**FURNISH ALL COMPONENTS REQUIRED TO PROVIDE A COMPLETE
POWER CONTROL SYSTEM THAT WILL DISTRIBUTE POWER TO
EXISTING STINGER EQUIPMENT AT CTA'S 98TH STREET RAIL SHOP FACILITY**

MEETING MINUTES OF PRE-BID ON APRIL 23, 2013

ADDENDUM NUMBER ONE (1)

E - 404

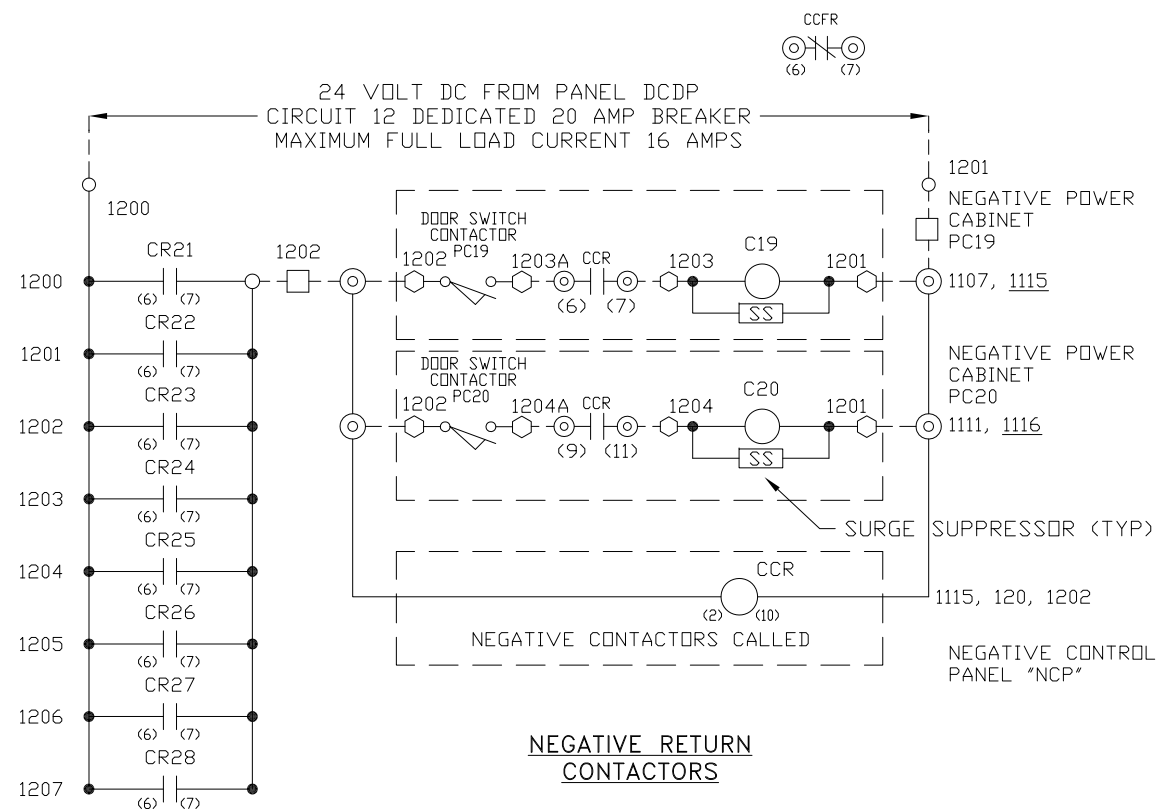
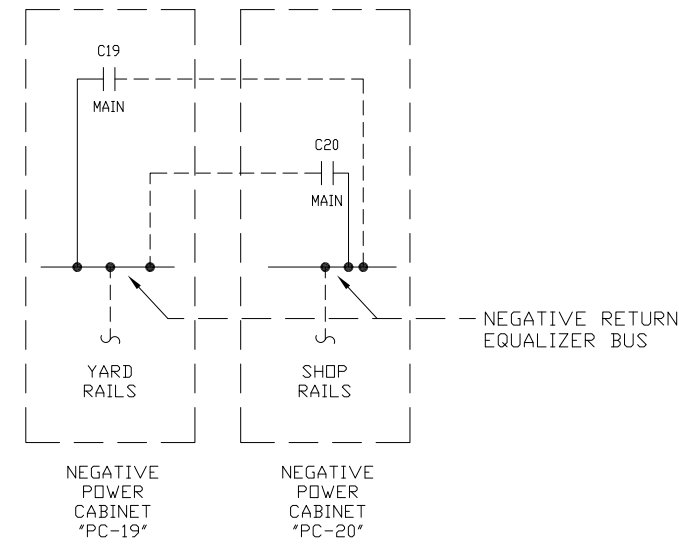
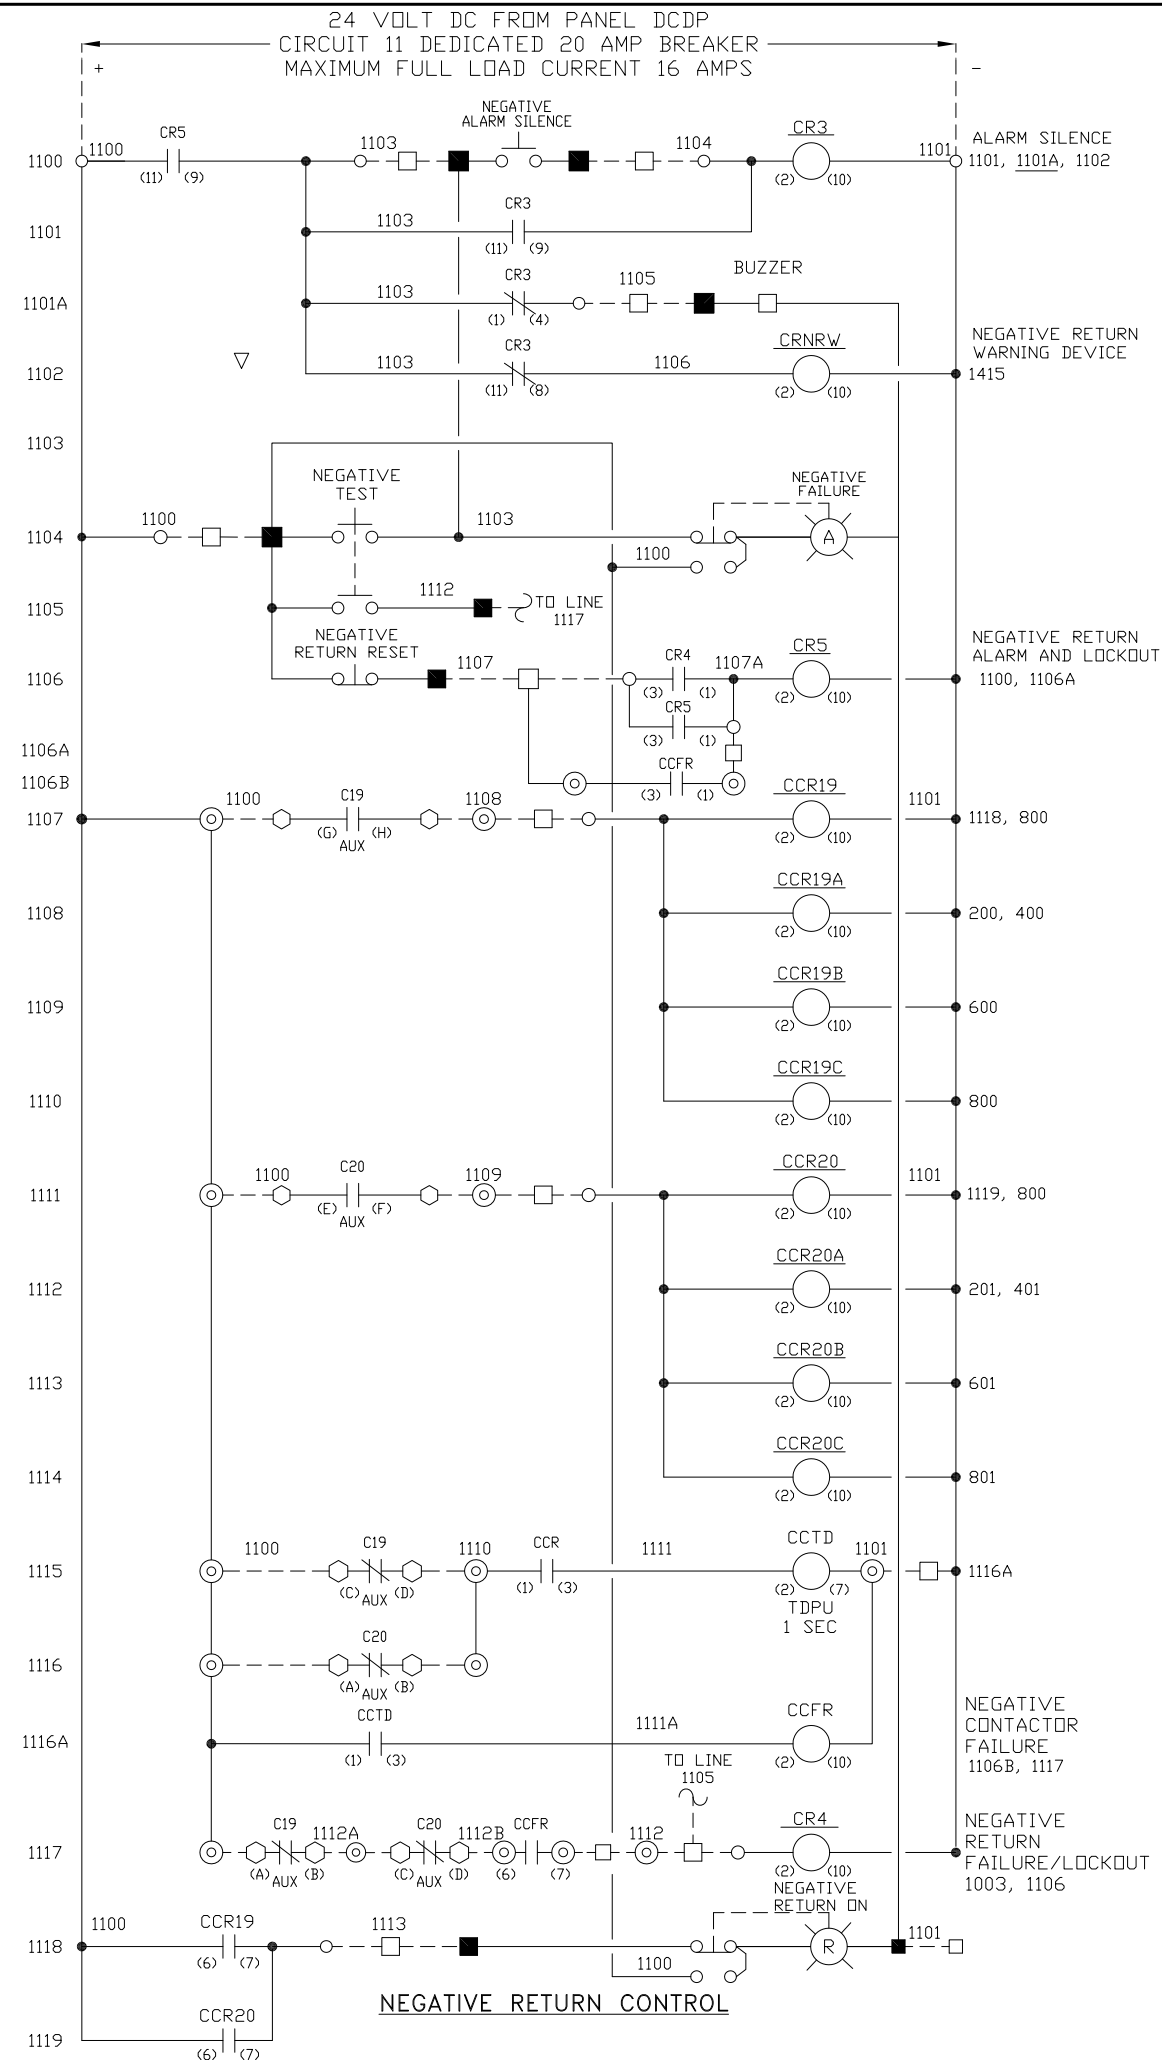
- A17. Yes. The use of 30 amp 600 volt screw type terminal blocks is acceptable. The Detail Specification has been revised accordingly.
- Q18. Detail Specification No. CTA 2011-0074, Section 2.7, Page D-7: This section requires that eight (8) warning devices be provided, yet Drawing E-404 only indicates a quantity of four (4). Which quantity is correct?

- A18. CTA requires that a total of six (6) warning devices be provided, two (2) of which will be spares. The Detail Specification has been revised accordingly.

E - 409

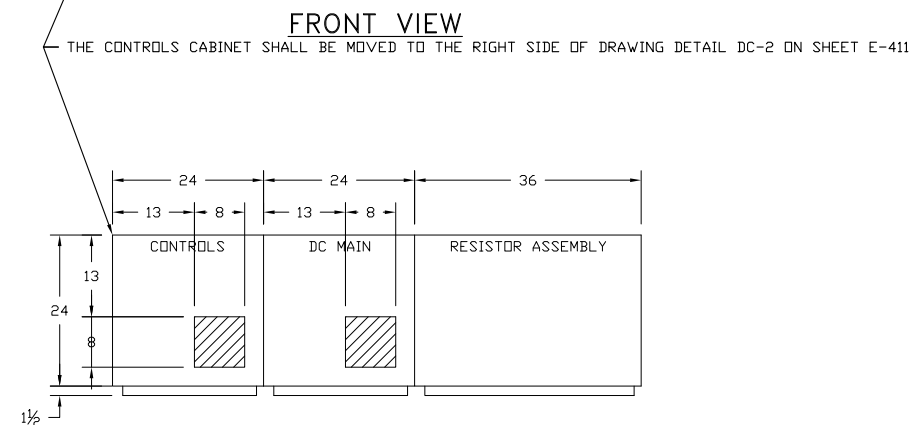
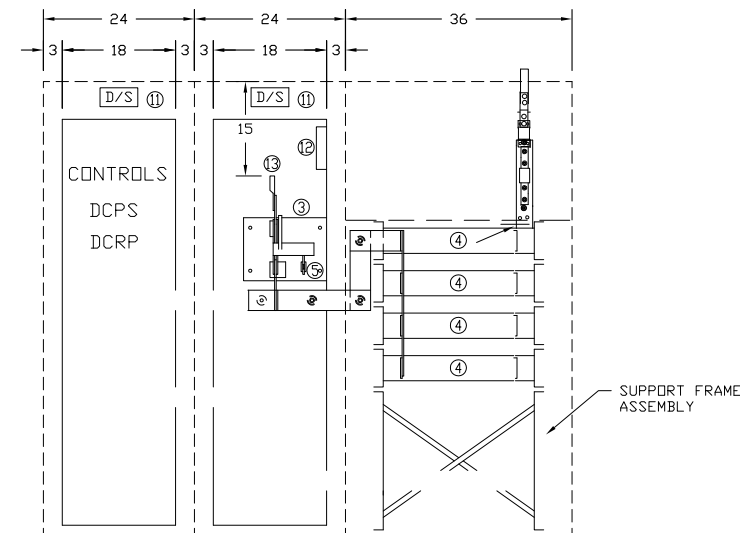
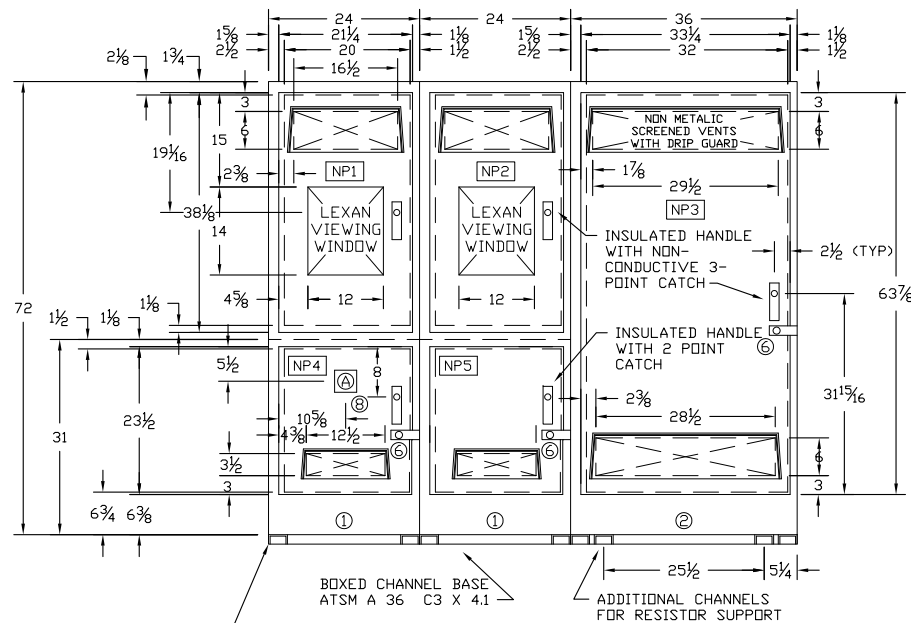
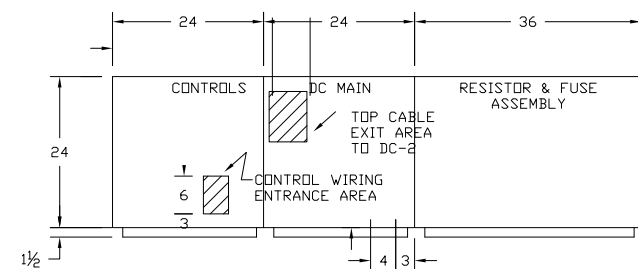
- A14. Yes. Cable connection is what CTA intended. The Detail Specification has been revised accordingly.
- Q15. Detail Specification No. CTA 2011-0074, Section 2.2, Item C. Page D-6: The DC test locations are currently listed in the Detail Specification as Track A, Track B, Track C-East, and Track C-West, yet that does not correspond to information listed on Drawing # 409. Does the Drawing supersede the specification?

- A15. No, the drawing does not supersede the specification. The correct information is Track A, Track B, Track C-North, and Track C-South. Both the detail specification and drawing have been revised accordingly.
